Our Reference: WTJ21-024 MOD
Your Reference: SSD 10371 MOD2

**PROPERTY AT 119 PROSPECT ROAD AND 50-52 SEAVIEW STREET, SUMMER HILL
LANDSCAPING AMENDMENT FURTHER DETAILS SECTION 4.55(1A) MODIFICATION APPLICATION TO
AMEND SSD 10371
PART 4, DIVISION 4, ENVIRONMENTAL PLANNING AND ASSESSMENT REGULATION 2021**

Thank you for your recent correspondence in relation to the above modification in relation to the redevelopment of Trinity Grammar School. Modification 2 (MOD2) of **SSD-10371** seeks minor amendments to the landscaping scheme at the School pertinent to design changes, following design development and project coordination of the scheme.

Figure 1 Approved Landscaping Plan

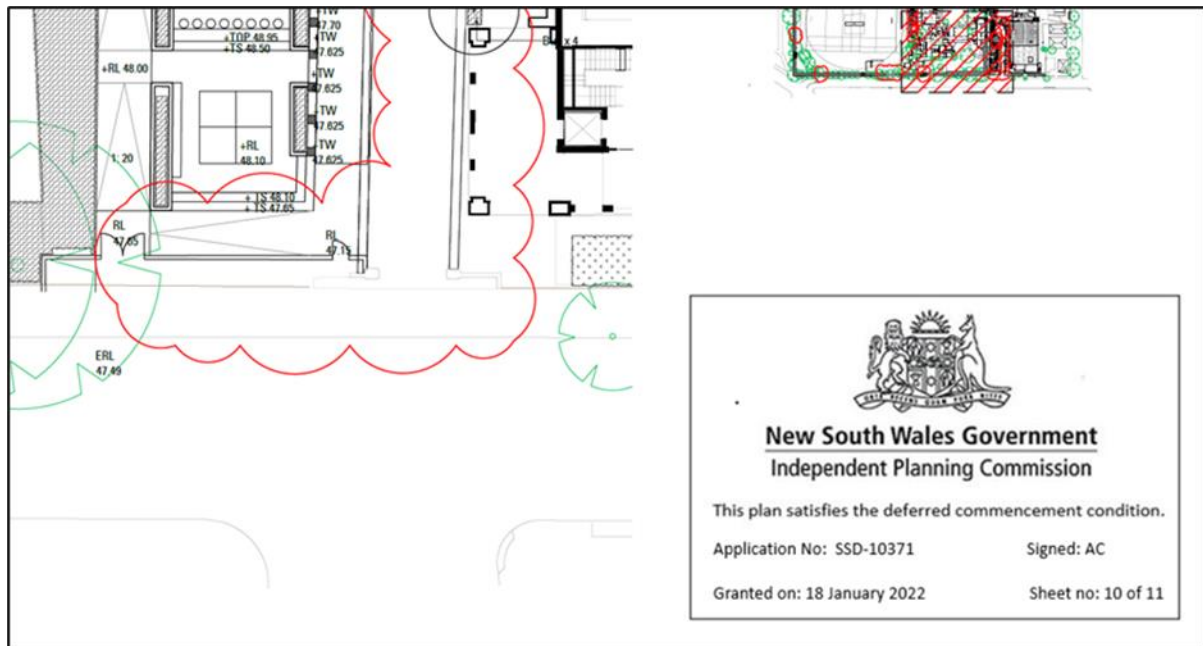
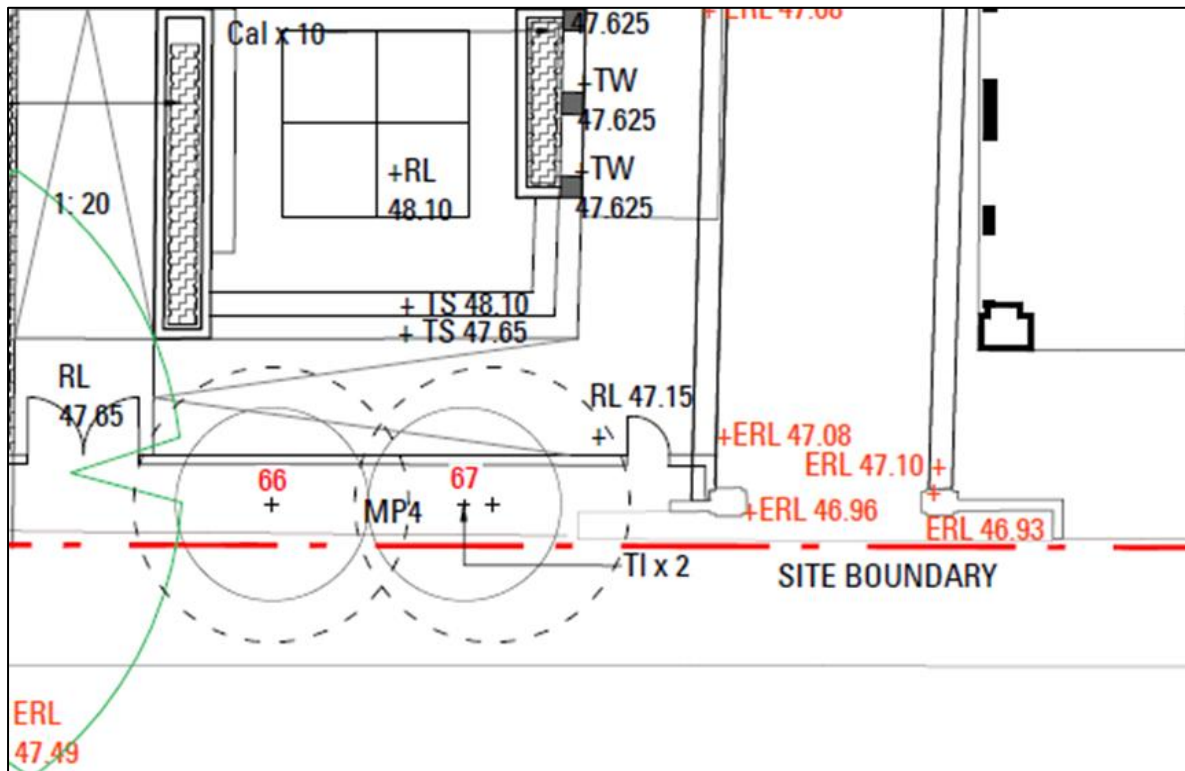
g) Removal of Brush Cherry Tree

As a result of design development, two trees have been identified as requiring removal to accommodate the approved hard landscaping design (which has been was approved under **SSD-10371** to allow for improved pedestrian access to Prospect Road during school bus drop off and pick up). **Figure 2** includes a snip from the proposed modified plans.

To support the tree removal required to accommodate the as-approved hard landscaping design and improved pedestrian access, an arboricultural report was undertaken to assess the health of the two trees required to be removed. One of these trees, the *Calondendrum capense*, has been recommended for replacement by the consulting Arborist due to its poor health and safety concerns over its declining health. The other tree, the *Syzygium austral*, whilst not in poor health is required to be removed to achieve the as-approved hard landscaping outcome.

Accordingly removal of both trees is required as:

- The recessing of the boundary treatment into the Site will impact on the existing tree root zone and adversely impact on the viability of the trees;
- The two trees are considered co-dependant and thus:
 - The removal of the tree in poor health would disrupt the canopy cover of the remainder tree; and
 - The two trees are read in symmetry with each other and thus the removal of one tree would materially interrupt and harm the appearance of the soft landscaping at this important node into the Site

Thus it is proposed to remove and replace the trees with new tree planting which would be similar in size and scale to the replaced trees on this frontage. The new trees would be within the as approved soft landscaping area and would be of the same species which ties into the prevailing and approved soft landscaping palate at the Site. For the avoidance of doubt, there would be no net loss of trees as a result of this aspect of the modification.
